# HISTORIC AND DESIGN REVIEW COMMISSION

**HDRC CASE NO:** 2019-632  
**ADDRESS:** 314 LAMAR ST  
**LEGAL DESCRIPTION:** NCB 528 BLK 1 LOT 4  
**ZONING:** R-5, H  
**CITY COUNCIL DIST.:** 2  
**DISTRICT:** Dignowity Hill Historic District  
**APPLICANT:** Timothy Patrick/FDN Home, LLC  
**OWNER:** 10X Properties Investments Series, LLC  
**TYPE OF WORK:** Rehabilitation, construction of a rear addition, and construction of a rear accessory structure  
**APPLICATION RECEIVED:** October 18, 2019  
**60-DAY REVIEW:** December 17, 2019  
**CASE MANAGER:** Edward Hall  
**REQUEST:**

The applicant is requesting a Certificate of Appropriateness for approval to perform rehabilitation, exterior modifications and to construct a rear addition at 314 Lamar. Within this request, the applicant has proposed the following:

NEW WORK RIGHT SIDE ELEVATION  
SCALE: 1/4" = 1'-0"

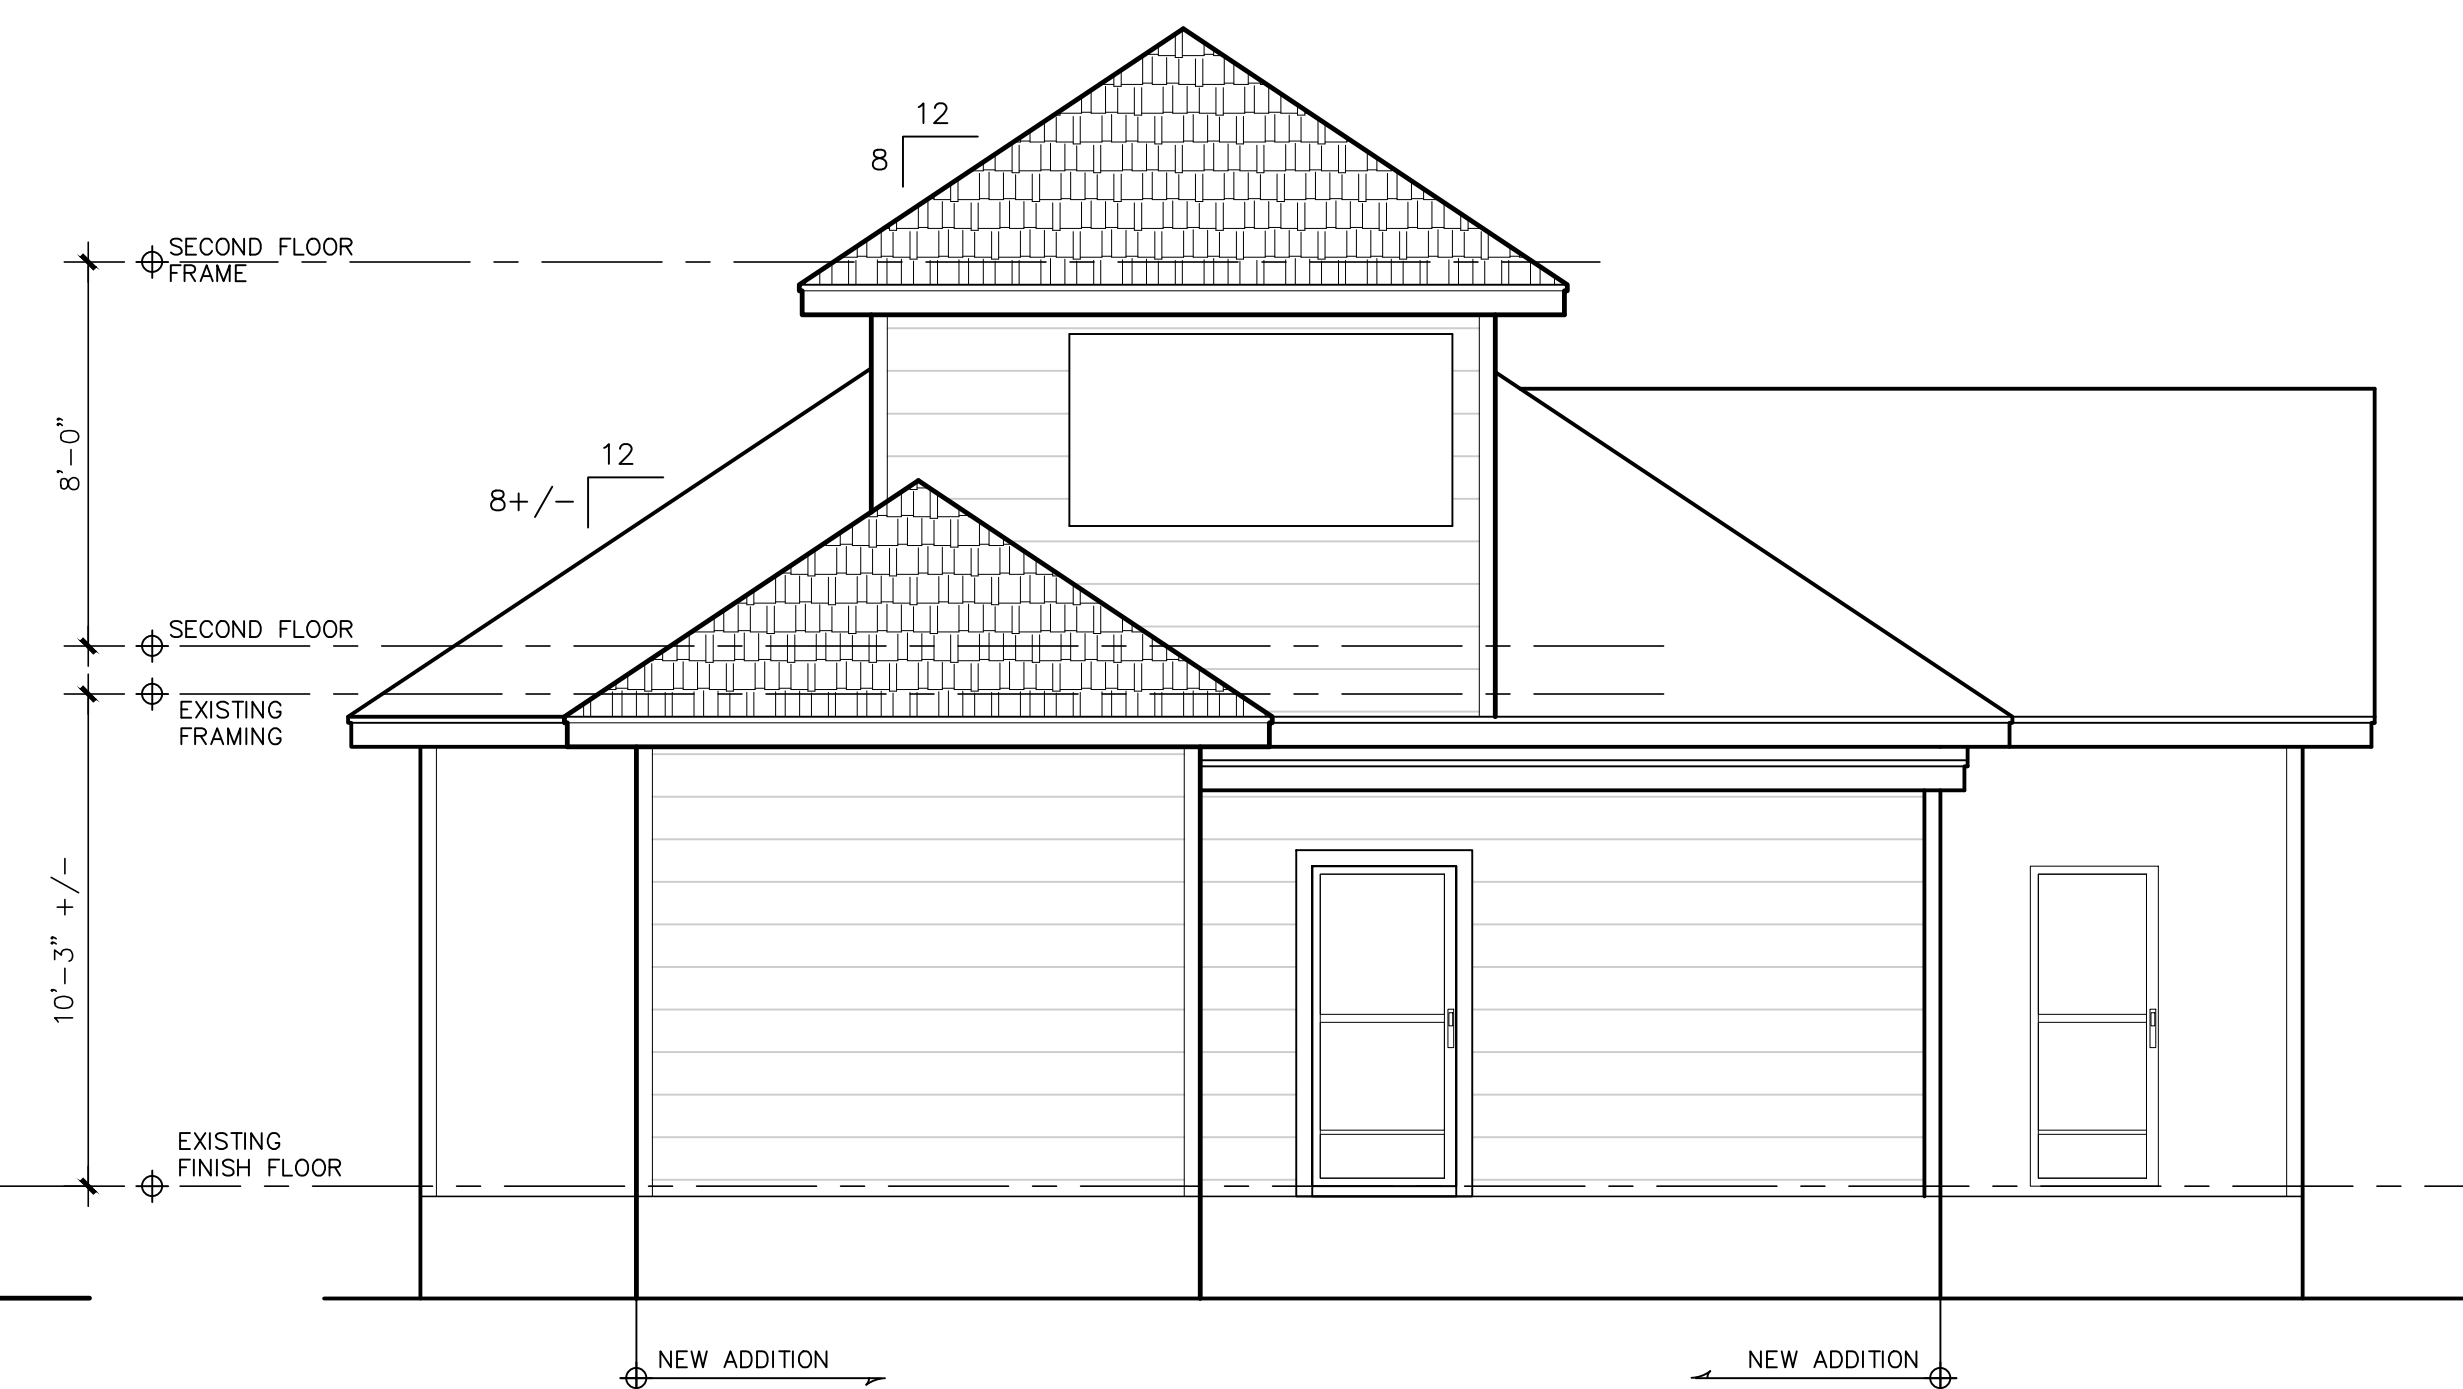
- g. **ROOF FORM** – The Guidelines note that roof forms should be comparable to those found on the historic house. Staff finds the roof form of the one story structure to be appropriate; however, staff finds that the roof form of the proposed two story addition to feature proportions that are inconsistent with those of the historic structure's roof.

- h. **HEIGHT** – The applicant has proposed an addition that features a second story element that is not subordinate to the height of the primary historic structure. Staff finds that the applicant should submit a line of sight study to provide additional information regarding the proposed addition's visibility from the right of way at Lamar and how the proposed addition may impact the historic structure's primary façade from the right of way at Lamar.

- k. ARCHITECTURAL DETAILS – Generally, staff finds the architectural details of the one story addition to be appropriate; however, staff is concerned regarding the height, profile and roof form of the proposed two story addition. Staff finds that the applicant should revise the proposed design to feature less of a tower massing and feature a massing and profile that is more in keeping with the that of the historic structure.
- l. REAR ACCESSORY STRUCTURE – The applicant has proposed to construct a rear accessory structure; however, the applicant has only provided a site plan for the structure at this time. Staff finds that the applicant should submit sufficient construction documents for this structure prior to staff providing a recommendation.

- 3. Staff does not recommend approval of item #3, the construction of a rear addition based on findings f through k. Staff recommends that the applicant modify the proposed roof form, massing and architectural details to be more in keeping with those of the historic structure and that does not modify the roof form of the historic structure. Additionally, staff recommends that the applicant submit a line of sign study to determine the appropriateness of the proposed rear addition's height. The proposed rear addition should not been visible when viewed from the right of way.
